SUNDRY NOTICES AND REPORTS ON WELLS

8. Well Name and No.
ADAMS FEDERAL #1

Adams Federal #1 – P&A Procedure

**Permanent Abandonment of Federal Wells
Conditions of Approval**

Current Wellbore Diagram

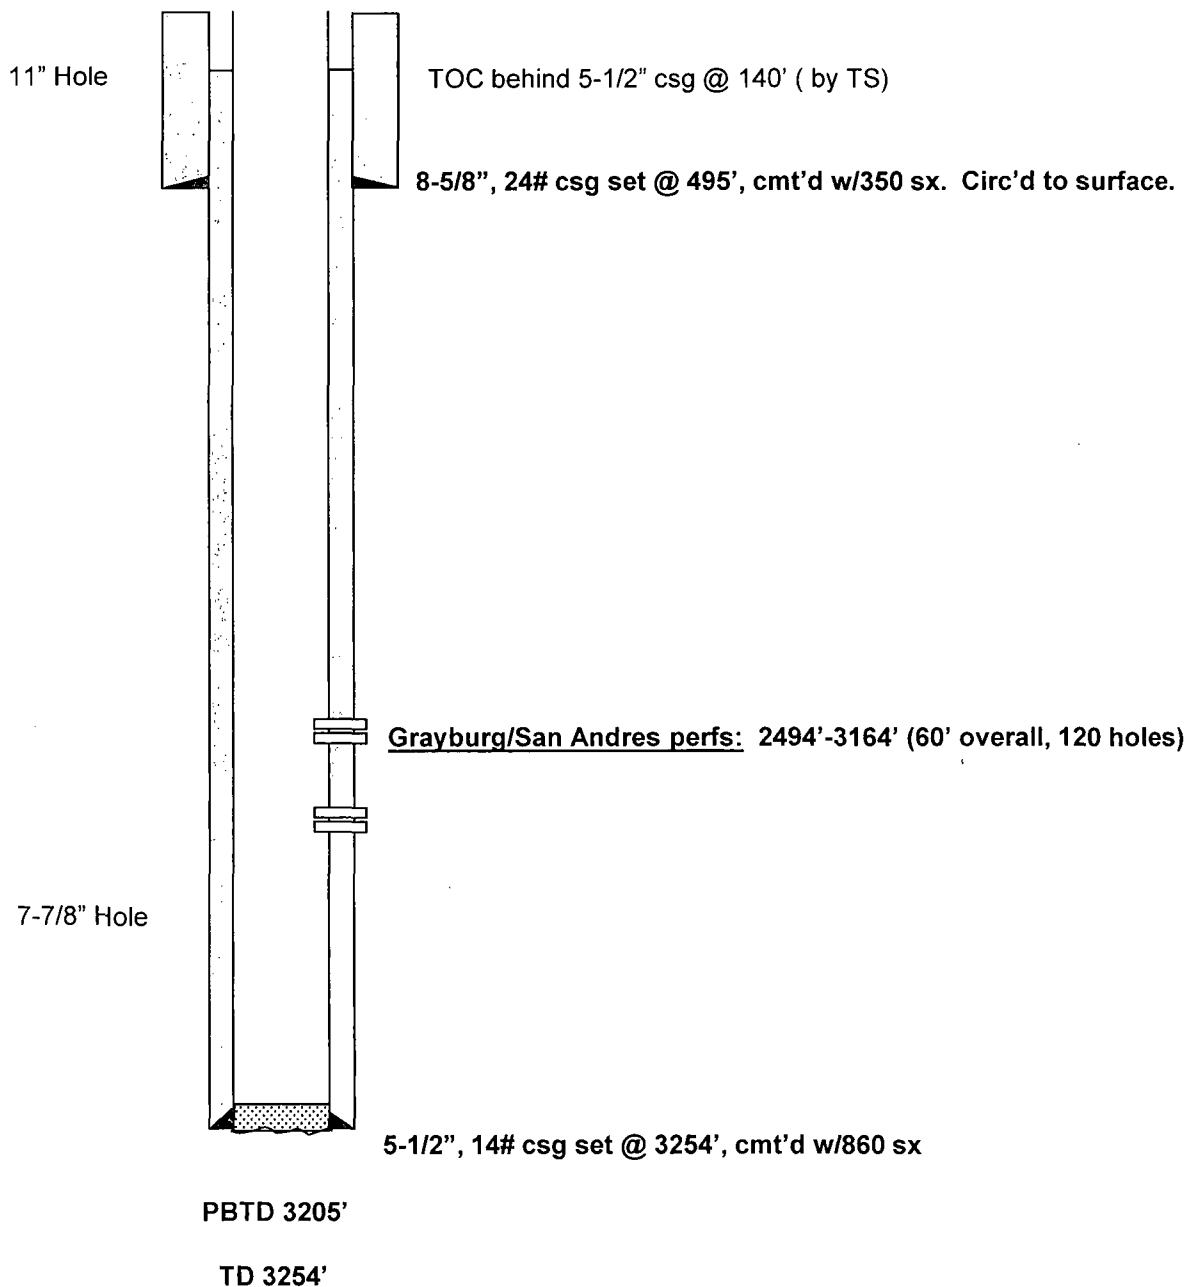
3. Cement plug #1 (perf and squeeze 5-1/2" casing): Set cement retainer at 2400' on 2-7/8" work string. Pump 200 sx cement plug (class C) from 2400'-3164'. *Complete SQZ, Pull out and spot 25 sx on top of CR. WOC Tag*

4. Circ hole above 2400' with plugging mud (60 bbls). POH and lay down work string to 545'. *Add plug. Spot 25 sx @ 864-764. WOC Tag (B/salt)*
5. Cement plug #2 (5-1/2" casing): Spot ^{25 m'7} 15 sx cement plug (class C) from 445'-545' (100' plug across the shoe of the 8-5/8" casing). POH and lay down remainder of 2-7/8" work string. ND BOP. *WOC Tag*
